ADDENDUM NUMBER 1

October 23, 2024

PROJECT: EUFAULA PICKLEBALL COMPLEX

GMC PROJECT NO. LMGM240002

- C. Sheet SF1.02 The following changes have been made:
 - a. Two (2) material callouts were added:

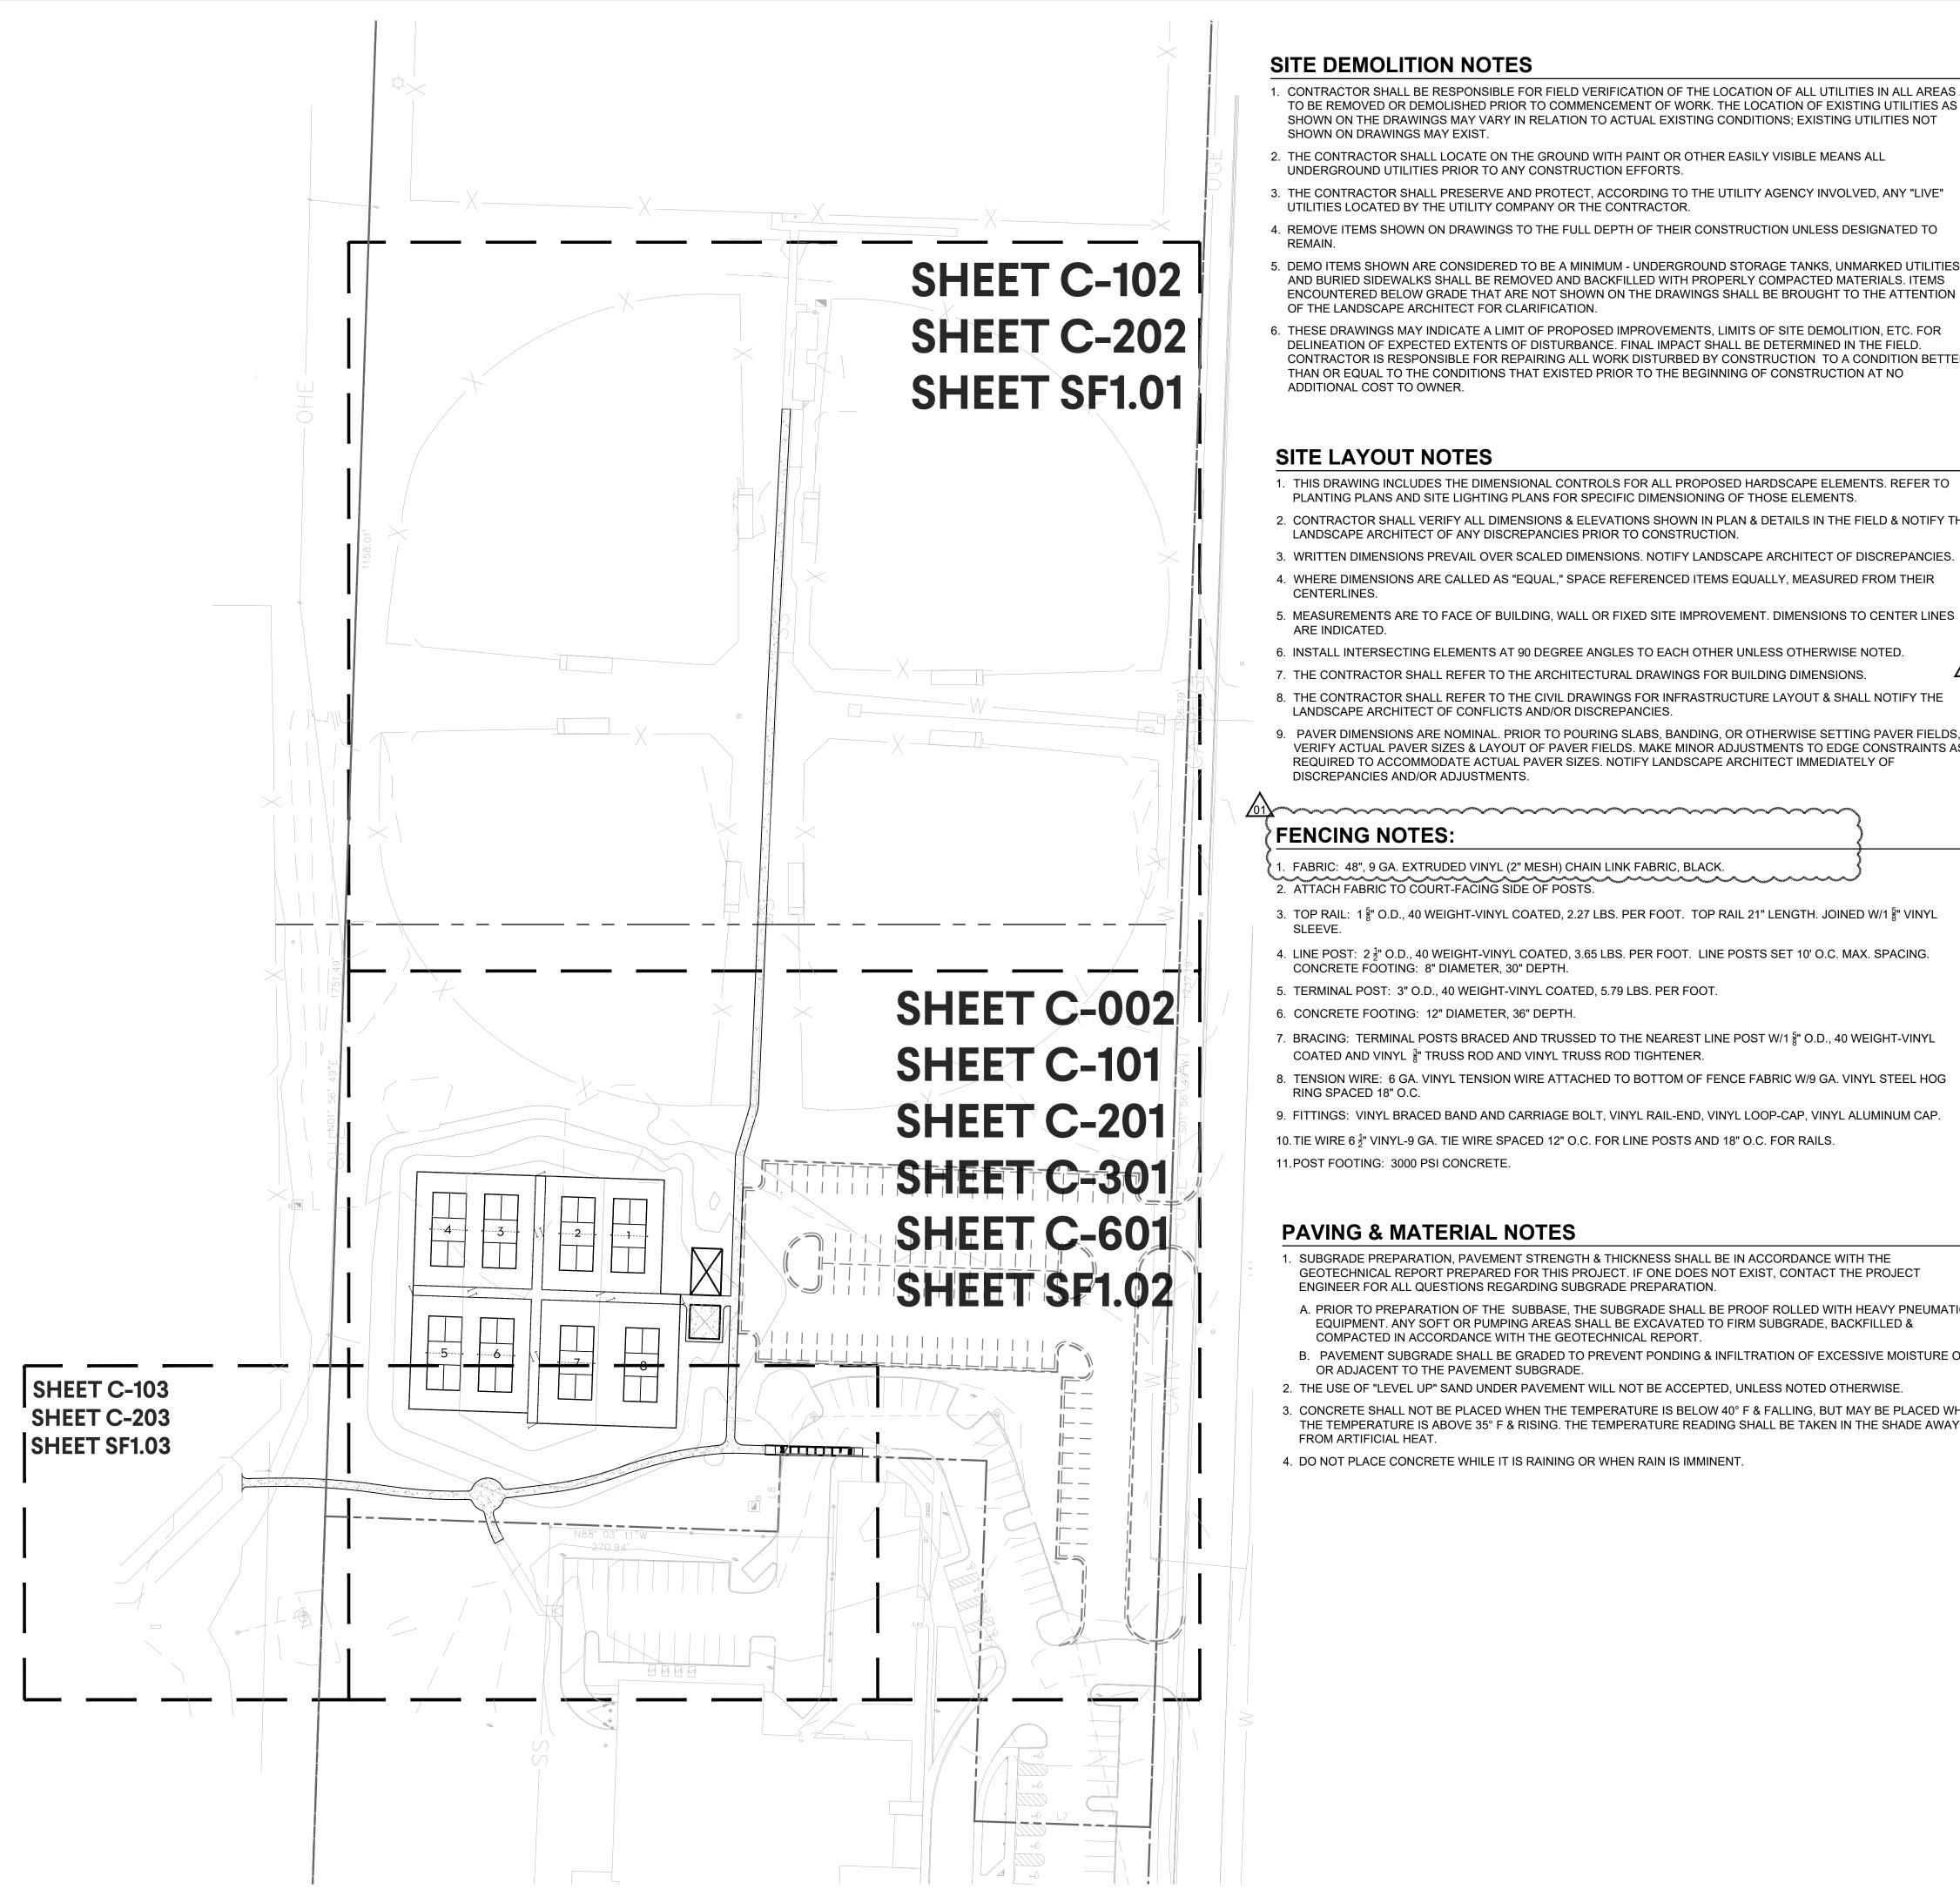
- i. P-101
- b. Two (2) material callouts deleted:
 - i. A-101 and A-102
- c. One (1) material callout added:
 - i. ST-102
